SERVICE LETTER

No. 532

Subject: Voltage Regulation Component Grounding

Models Affected: PA-23-250 (Six Place) Aztec "D"
PA-30 Twin Comanche "C"
PA-31 and PA-31-300 Navajo

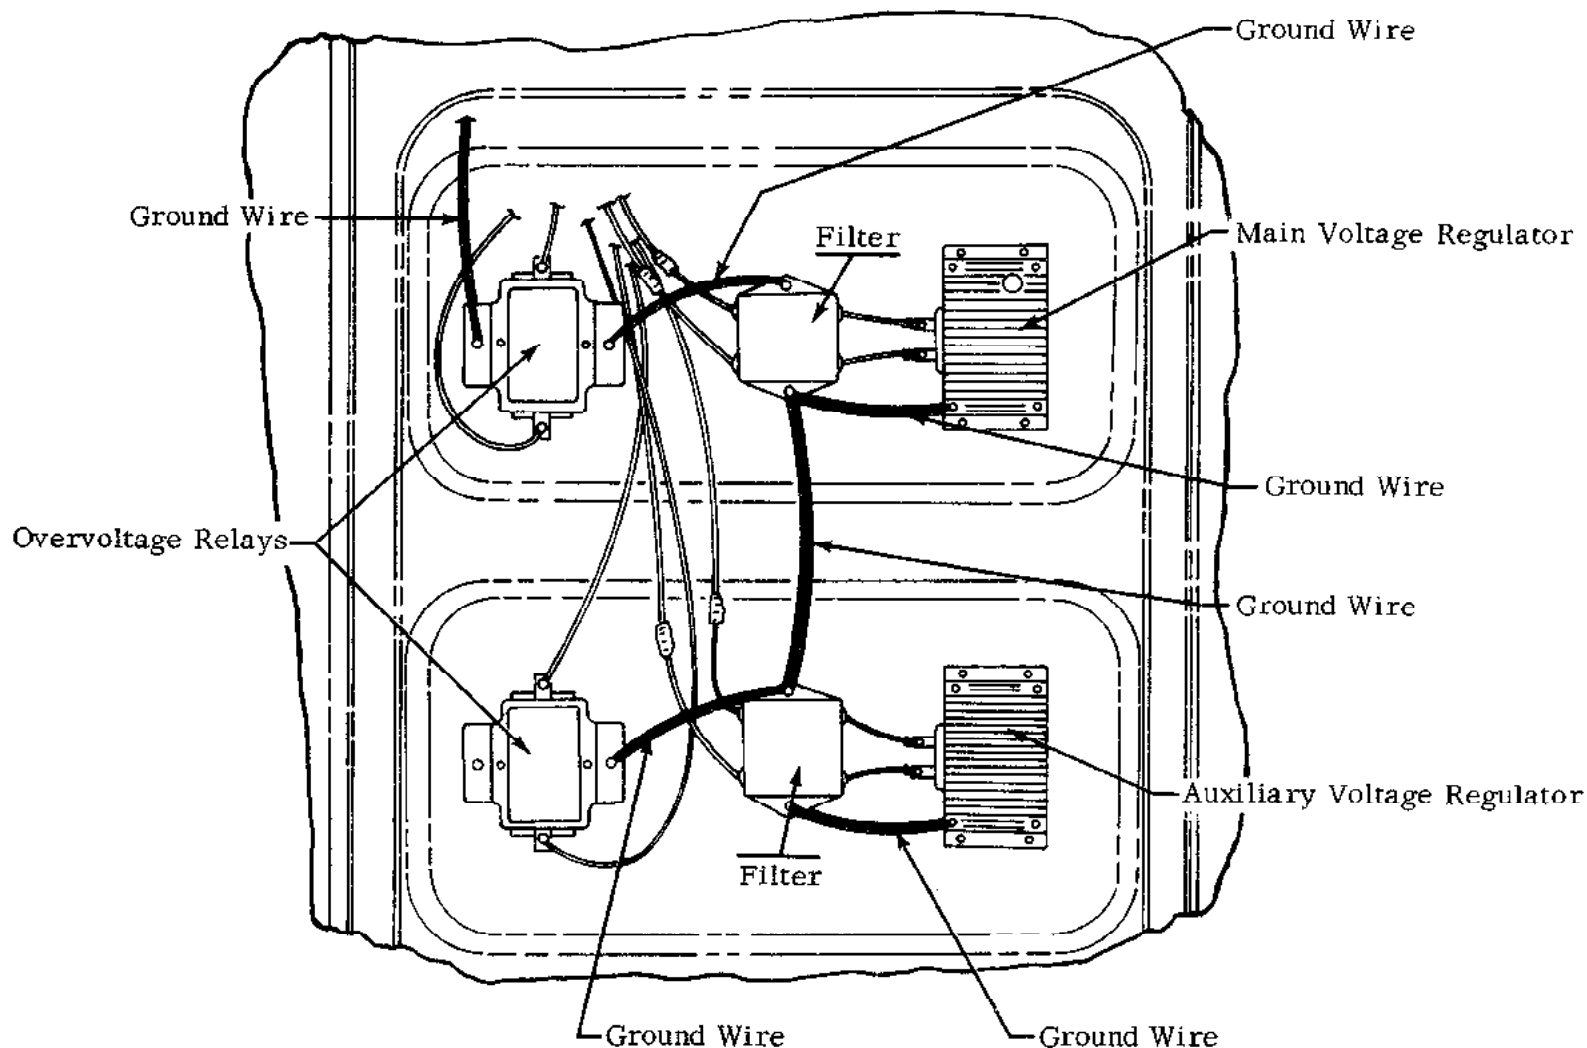
Purpose: To provide a supplemental method of grounding the aircraft voltage regulation system components to the aircraft structure. See sketch attached to this letter for general information.

This Sketch represents the Aztec "D" Voltage Regulation Component Grounding Modification, and is similar to the modification required for affected PA-30 and PA-31 aircraft.

Instructions: Contained in Kits No. 760 331 (PA-23-250 six place Aztec "D"), 760 332 (PA-30 Twin Comanche "C") and 760 333 (PA-31 and PA-31-300 Navajo) Voltage Regulation Component Grounding Installation

Detailed Sketches relative to the above referenced aircraft are contained in the applicable Voltage Regulation Component Installation Kits, specified on the Service Letter.
